GENOA CHARTER TOWNSHIP BOARD
Regular Meeting
June 19, 2017
6:30 p.m.

5. Consideration of a request for approval of special land use, environmental impact assessment and site plan for a proposed 30,000 sq.ft. warehouse/storage addition to the existing A & F Wood Products located at 5665 Sterling Drive, Howell. The request is petitioned by Schonscheck Inc.

Attention:	Kelly Van Marter, AICP Planning Director and Assistant Township Manager
Subject:	A&F Wood Products – Special Land Use and Site Plan Review #2
Location:	5665 Sterling Drive – terminus of Sterling Drive, west of Dorr Road
Zoning:	IND Industrial District

Re: A&F Wood Products Addition Site Plan Review #2

A & F WOOD PRODUCTS DIMENSION & PAVING PLAN

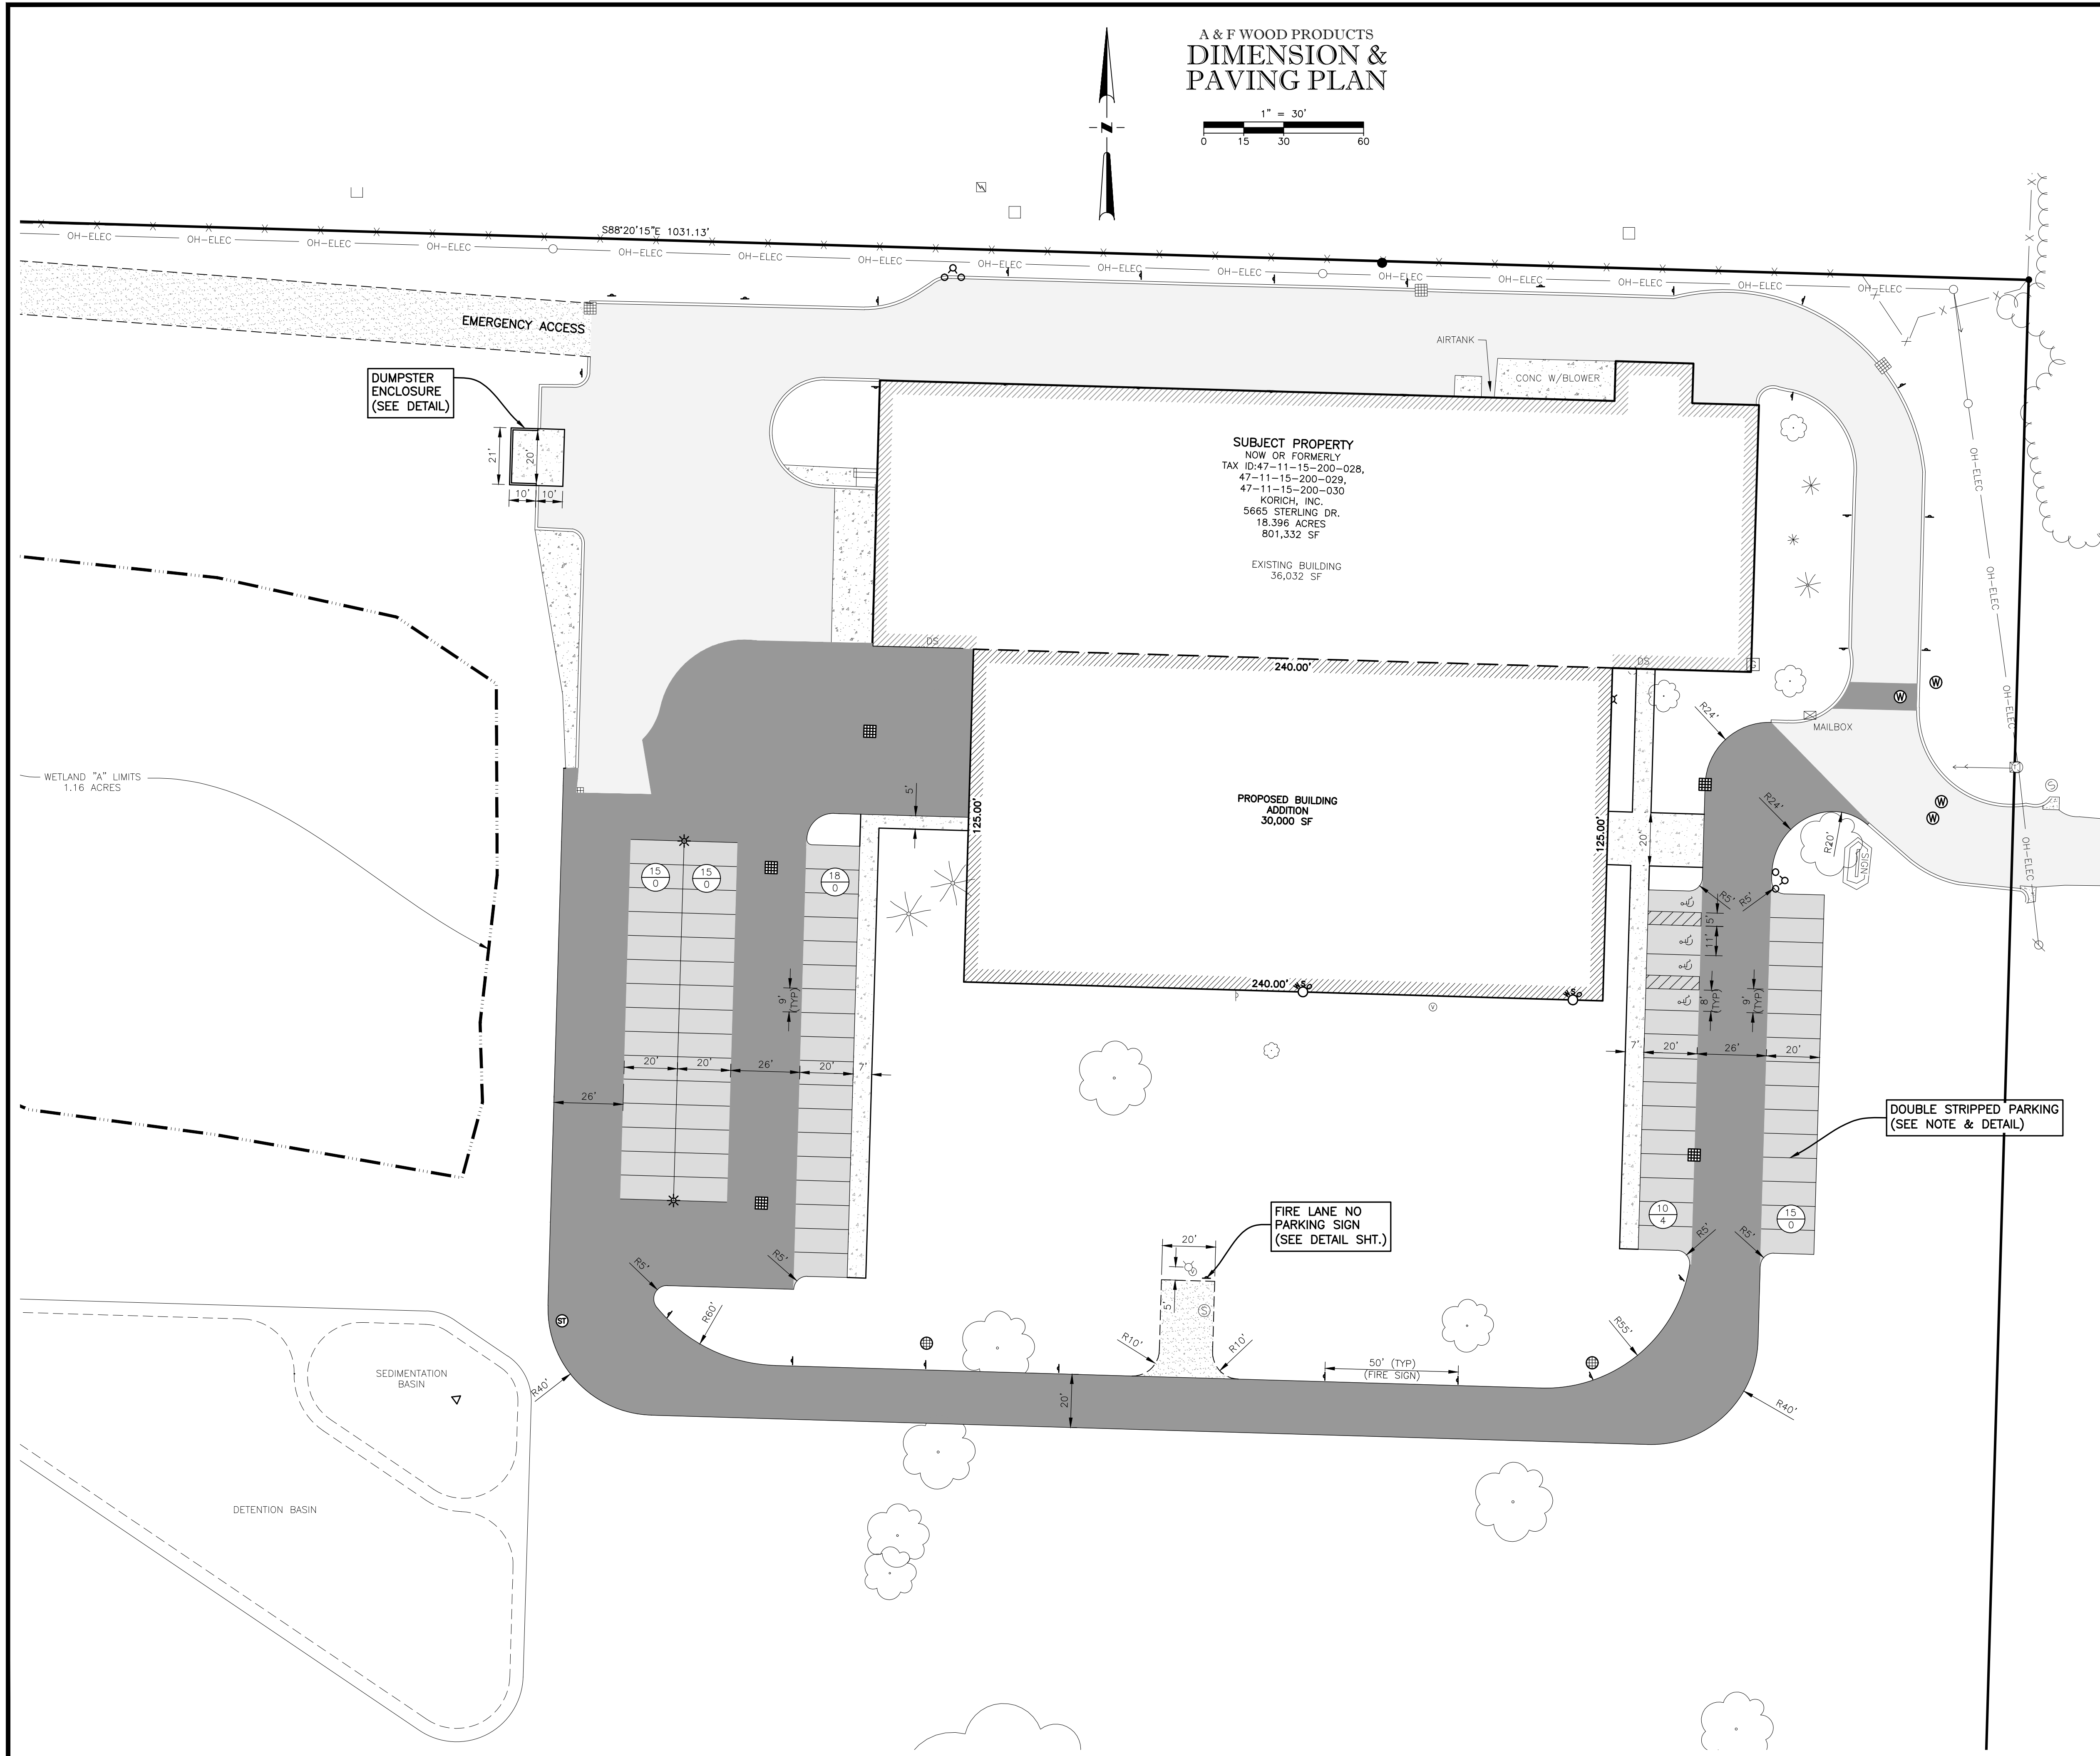
- 3. Parking.** The site plan provides the 77 parking spaces required for this proposal, including 4 barrier-free spaces.

The parking spaces and drive aisles meet or exceed the dimensional standards of Section 14.06. A detail and note on Sheet C-2.0 show the use of looped (double striped) spaces, as required.

A & F WOOD PRODUCTS VEHICLE CIRCULATION PLAN

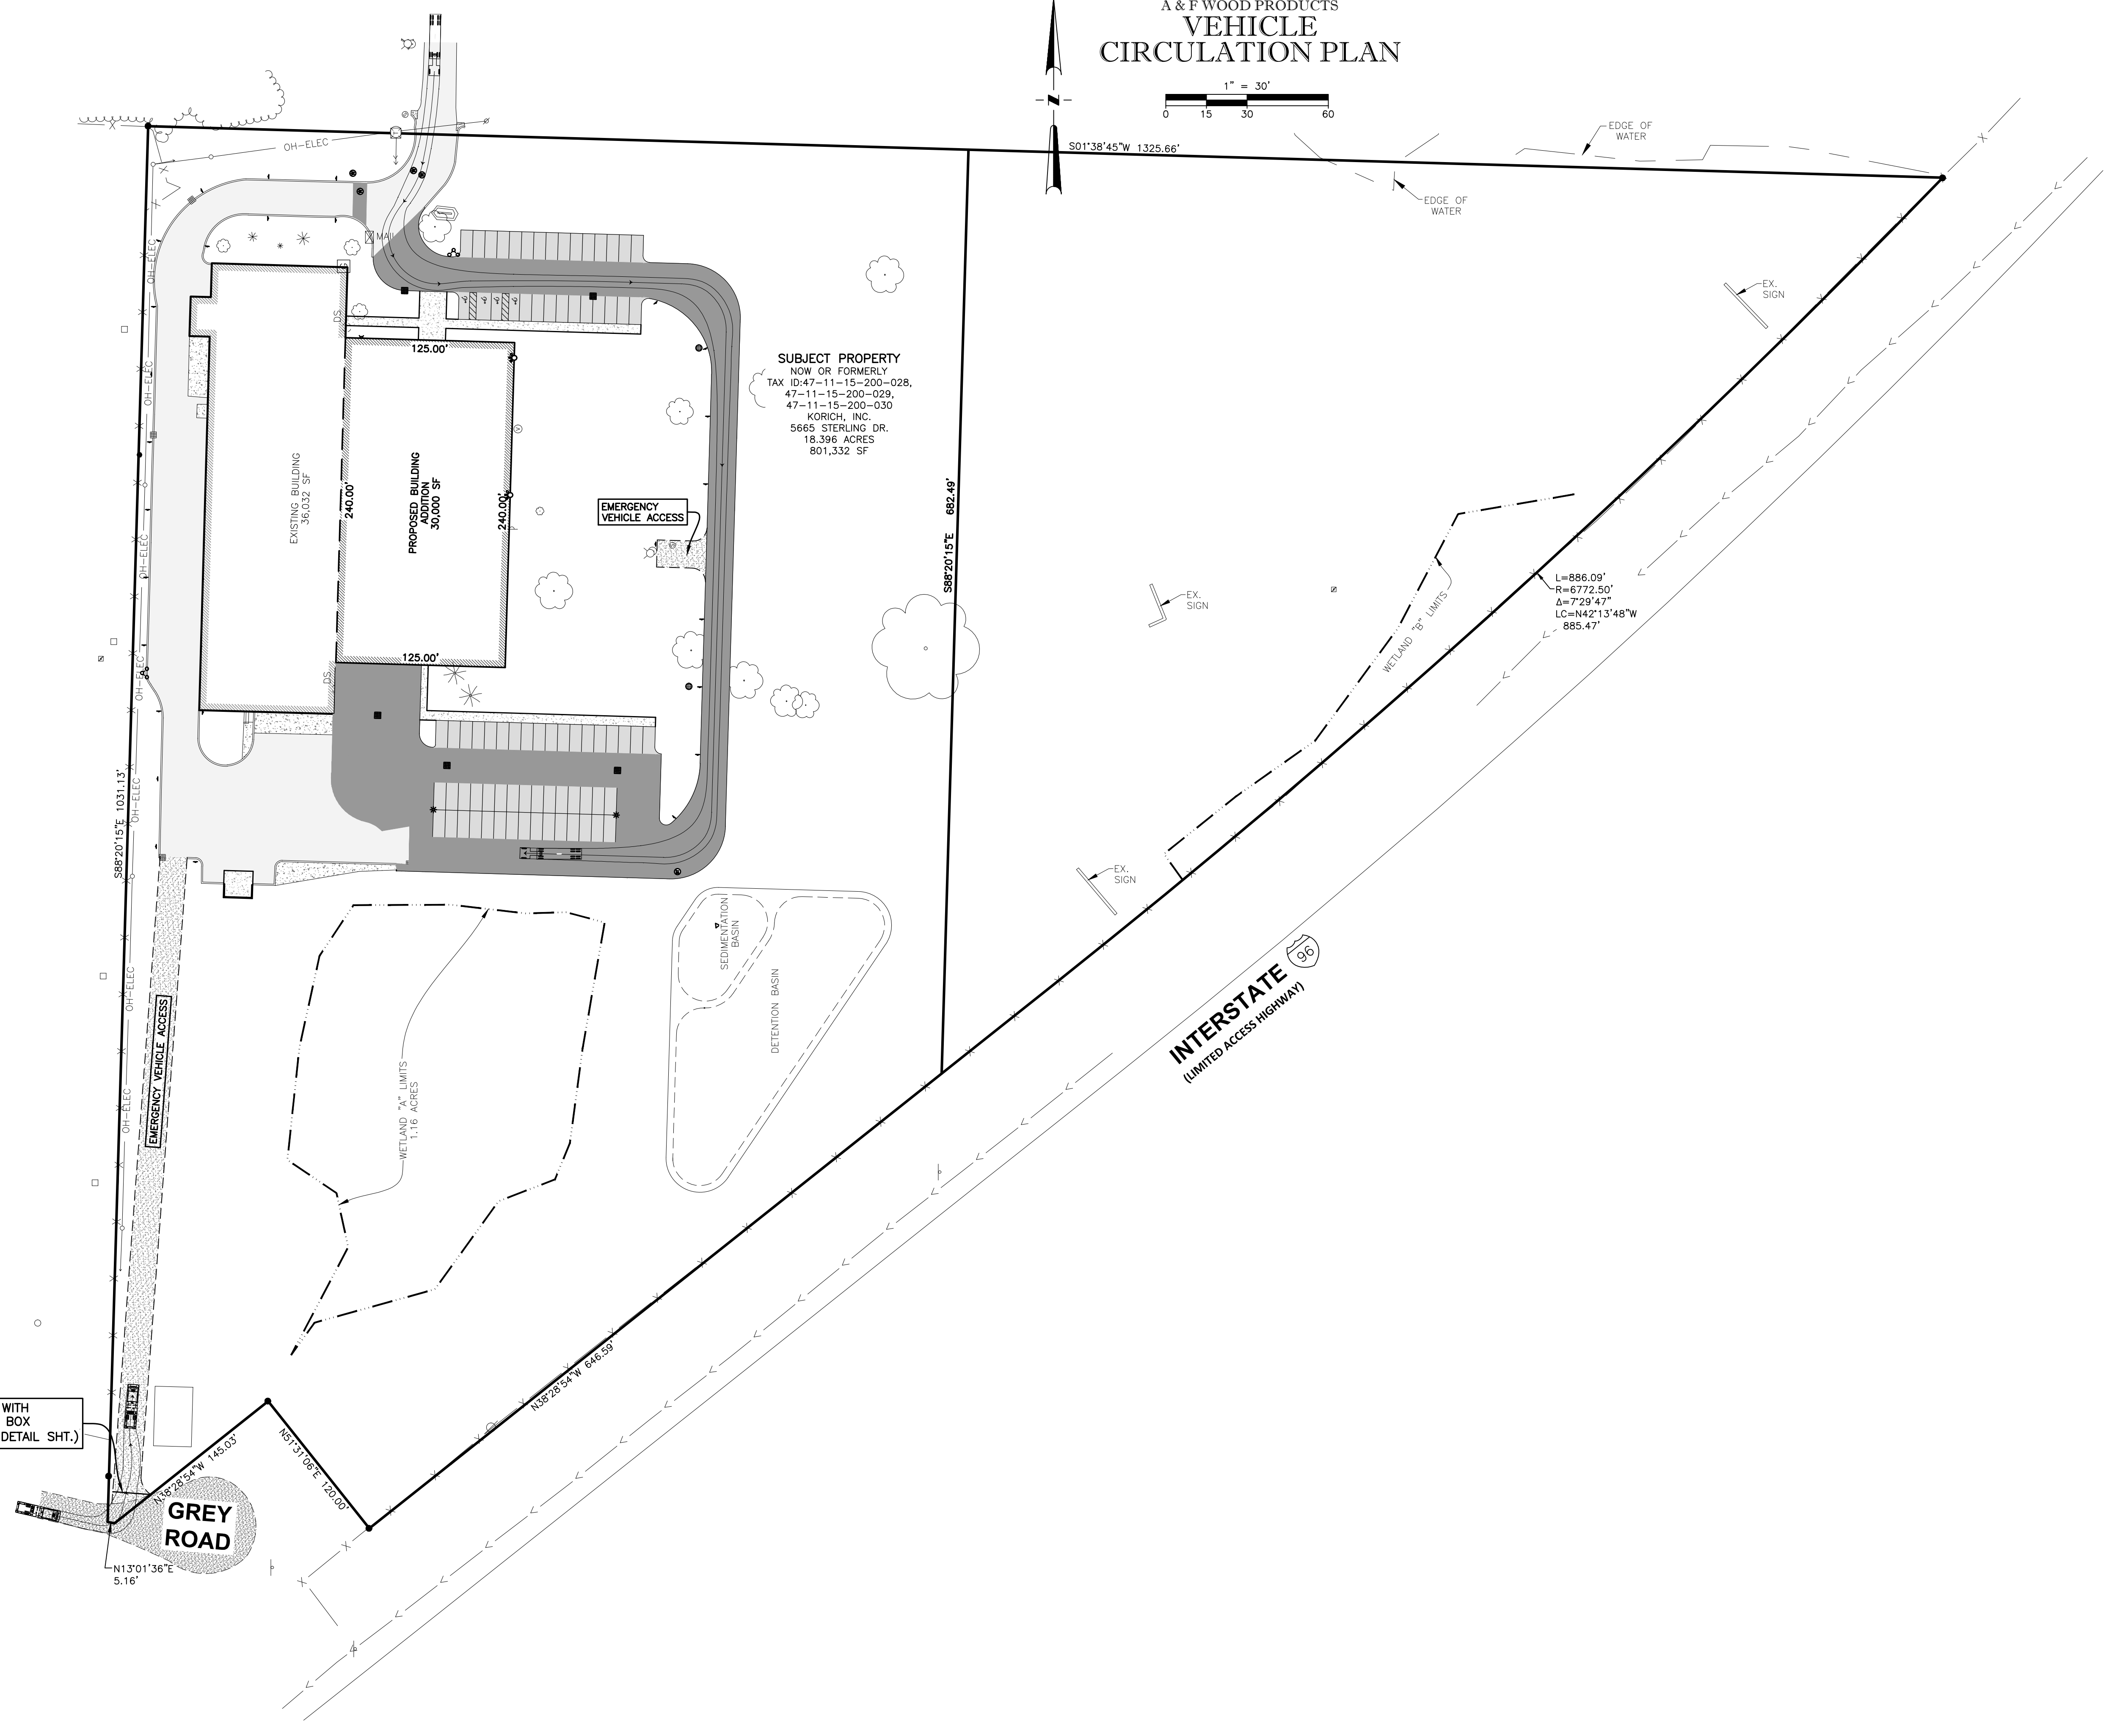
Drive aisles meet or exceed Ordinance standards and a truck turning template is shown on Sheet C-3.0 demonstrating that large trucks with trailers can adequately navigate.

FIRE LANE SIGN PLACEMENT DETAIL
NOT TO SCALE

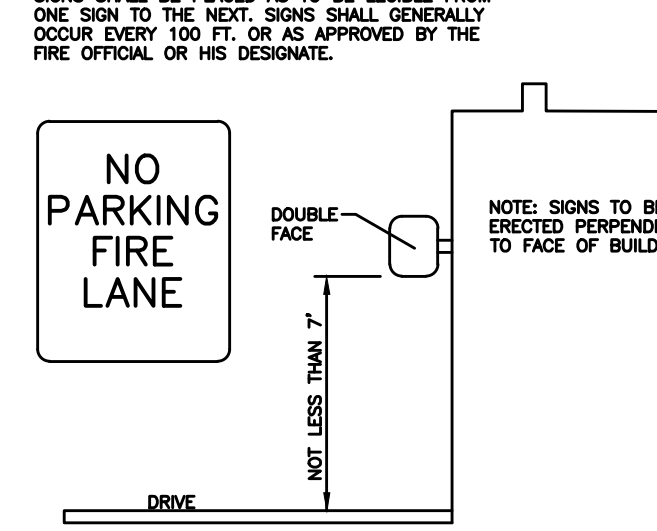
include a detail of the fire lane sign in the submittal. Access roads to site shall be provided and maintained during construction. Access roads shall be constructed to be capable of supporting the imposed load of fire apparatus weighing at least 75,000 pounds. **(Locations and detail of signs is provided in the submittal. Additional signage is required along the west curb edge near new parking area).**
